Our ref: 31040 NRW01 H1 assessment

**RE: PAN-029406: GLAN LLYN H1 ASSESSMENT**

Further to submission of our report presenting an H1 assessment of the proposed discharge to Monks' Ditch from the Glan Llyn residential development (30937 R5) and subsequent discussion between you and Chris Wilson of Rodgers Leask Ltd (RLL), you replied by email to Chris (22 July 2025) with some questions. This letter provides a response to those questions.

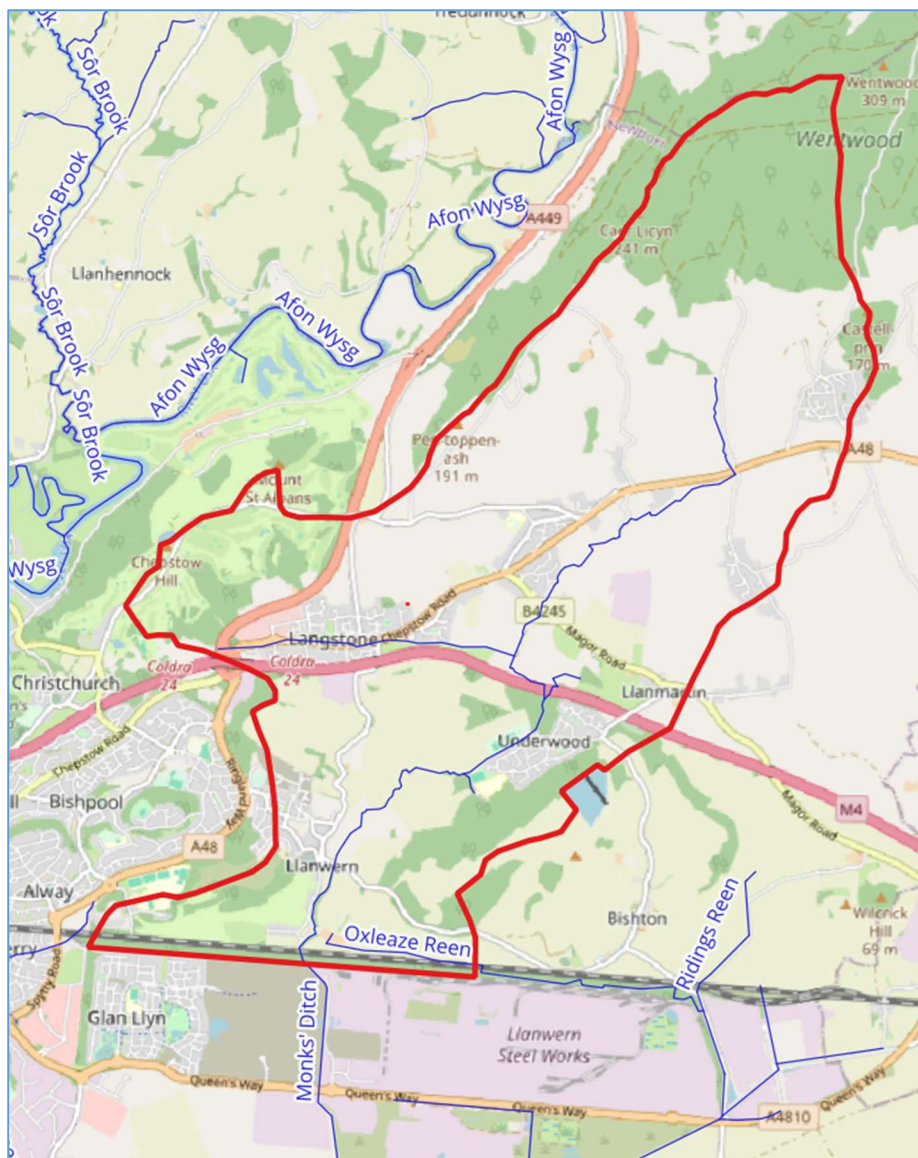
You asked: *"Can you clarify why the estimated flow rates were used for monks ditch rather than requesting hydrology data."*

As you are aware from discussion, NRW was unable to provide hydrology data. However, we have now calculated flow rates using LowFlows2 software and have applied the mean annual flow that results from that. The catchment boundary used for the calculation is shown for your information in the figure below.

The calculated mean flow (302 l/s) is smaller than the estimated flow that was previously applied (537 l/s). The calculated value has been used in the updated H1 assessment calculations that are attached as Appendix B.
